City of Mississauga Department Comments

Meeting date:2022-08-25 1:00:00 PM

Property Address: 5461 Red Brush Dr

File:A175.22

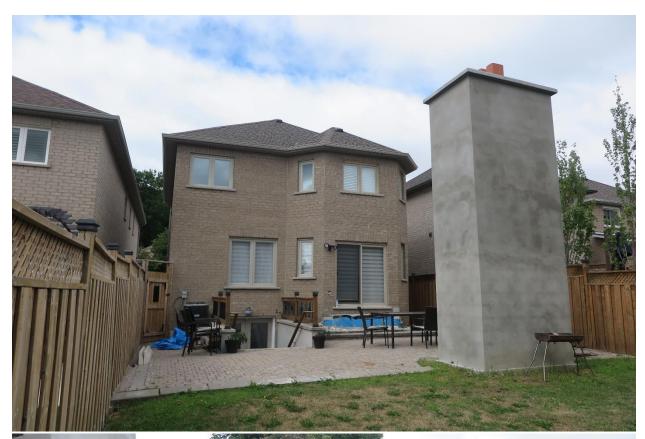
We have re-visited the property and are attaching recent photos which depict both the fireplace structure (variance#7) and the existing accessory structure (shed). The Grading Plan approved for this property, Lot# 92 Plan 43M-1243 (Grading Plan C-33389) indicates that the drainage from the rear yard was designed to be directed to the existing catch basin on the abutting property to the north (Lot# 91).

The applicant has altered the approved drainage pattern by constructing a shed and garden area where a drainage swale across the rear property line would typically be constructed. Although the drainage pattern has been altered on this property, we cannot confirm if this has had an impact on the abutting properties as the Grading Plan C-33389 indicates that the drainage pattern of the abutting properties are independent of this property. We do note that in general adequate setbacks should be provided to accessory structures, in this instance 0.61M to ensure that approved drainage patterns are not impacted.
